DECISION DATE: May 18, 2021

RE: Case Number: AA-2020-7465-PMLA-CN-HCA
Related Case: N/A
Address: 1465 - 1467 South Cardiff Avenue
Community Plan: West Los Angeles
Zone: R2-1-O
District Map: 129B169
Council District: 5
CEQA No.: ENV-2020-7465-CE
Legal Description: Lot 111, Block None, Tract
TR 7580

PRELIMINARY PARCEL MAP NO.

TITLE: PRELIMINARY PARCEL MAP NO. 1465 CARDIFF AVENUE, LOS ANGELES, CA 90035	
CLIENT: LADDA, LLC	JOB NO.: 20-16368
SCALE: 1" = 8'	DATE: 10/20/2020
DESIGNED BY: F.G. / SA	REVISION (S):
PPM BY: MK	SHEET 1
100% IN	OF 1 SHEET
CHECKED BY: C.D.L.

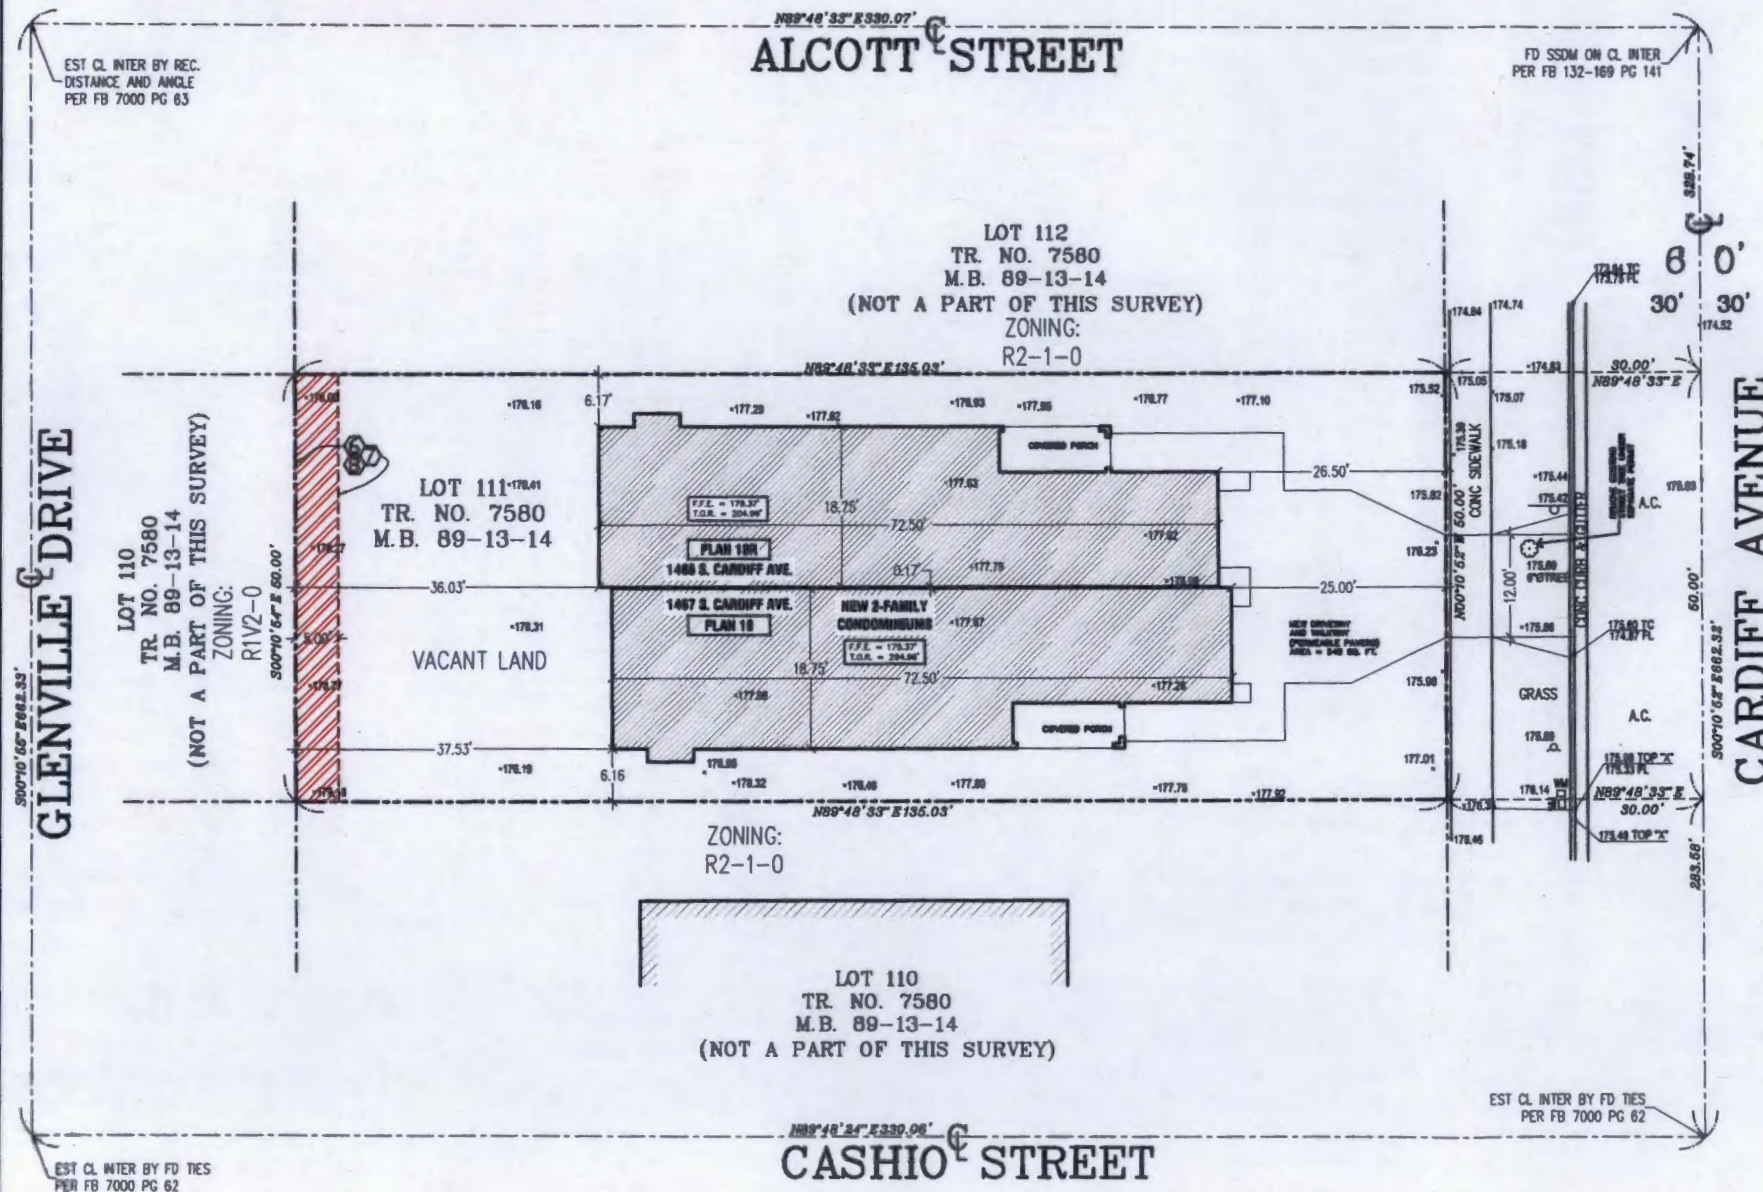
1. That the existing sanitary sewer easements adjoining this subdivision be clearly designated on the final map.
2. That the subdivider make a request to the West Los Angeles District Office of the Bureau of Engineering to determine the capacity of existing sewers in this area.

The submitted Map may not comply with the number of parking spaces required by Section 12.21 A.4 (a) based on number of habitable rooms in each unit. If there are insufficient numbers of parking spaces, obtain approval from the Department of City Planning.

The submitted Map may not comply with the number of guest parking spaces required by the Advisory Agency.

Backup space for parking space with less than 26'-8" shall provide sufficient parking stall width and garage door opening width to comply with the current Zoning Code requirement.
